**Agreement to NP/SC 7799 – HNB R3 and R4 Graphite Cores – Post Keyway Root
Cracking Safety Case**

**Hunterston B Power Station
Project Assessment Report**

Agreement to NP/SC 7799 – HNB R3 and R4 Graphite Cores – Post Keyway Root Cracking Safety Case

Figure 4 – Proxy-MCB representation

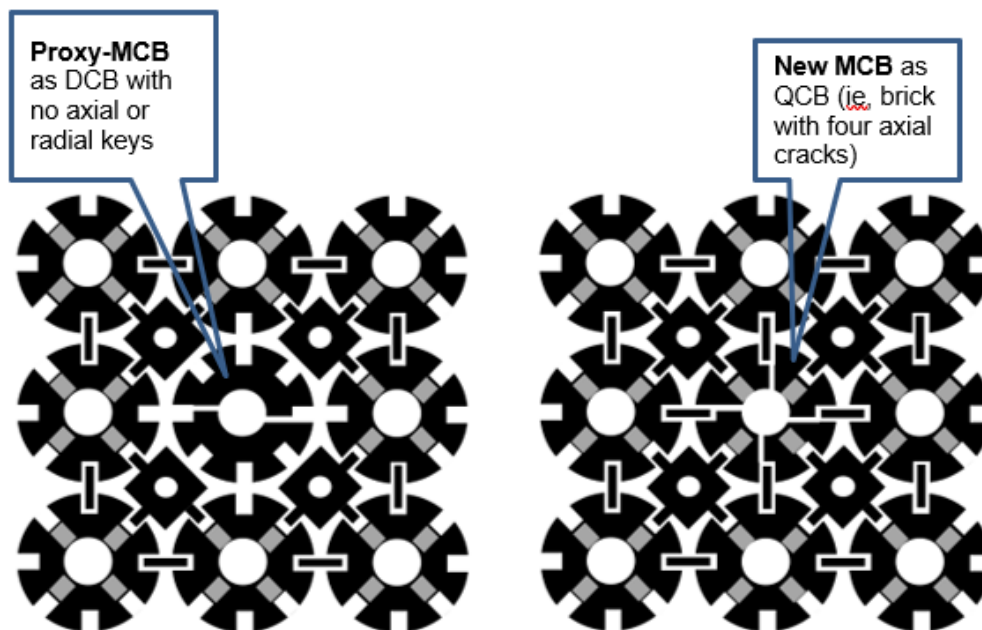
22. In previous safety cases, EDF NGL modelled multiply cracked bricks (MCBs) using an approximate representation, termed proxy-MCB, where an MCB was represented as a Doubly Cracked Brick (DCB) but with its radial and axial key/keyway connections removed.

23. In NP/SC 7799, EDF NGL has updated the way MCBs are modelled. An MCB is modelled as a fuel brick with four full-height axial KWRCs, such that the brick is split into four symmetrical quarter segments which can move independently, while keys are maintained. The same approach was adopted in the normal operation and the seismic whole core models.
24. In the specialist structural integrity inspector's view (Ref. 10), the new MCB representation is not particularly novel as it applies the same principles used for modelling doubly cracked bricks (DCBs). It is also more representative of the physical behaviour of a cracked brick with multiple segments. The change in MCB representation is therefore considered to be acceptable for use in the whole core models.

Figure 5 – General illustration of the safety case approach to demonstrating margins

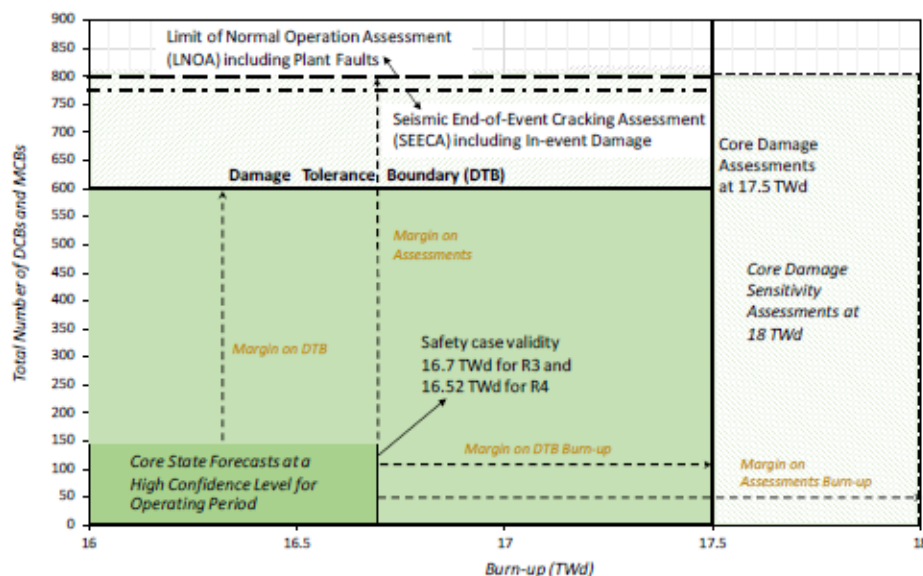
- **Damage Tolerance Boundary (DTB):** Represents the limit of brick cracking for which seismic damage tolerance assessments demonstrate with high confidence that no control rod is impeded by the graphite core during an infrequent seismic event. The difference between a forecasted core state over a specified period of operation and the DTB represents the available margin on core state as shown in Figure 5.

- **Limit of Normal Operational Assessment (LNOA):** For normal operation and plant-based faults, demonstration that control rod entry is not impeded is undertaken for an extent of cracking which meets or exceeds that at the DTB. The difference between a forecasted core state over a specified period of operation and the LNOA represents the available margin on core state for normal operation and fault conditions as shown in Figure 5.

29. In the specialist inspectors view (Ref. 10), the new terminology does not lead to a change in approach from the extant safety case NP/SC 7766 of how adequate margins between core state forecasts and assessment limits are demonstrated. The purpose of the DTB is equivalent to the purpose of the CEDTL (i.e. both are assessment limits).
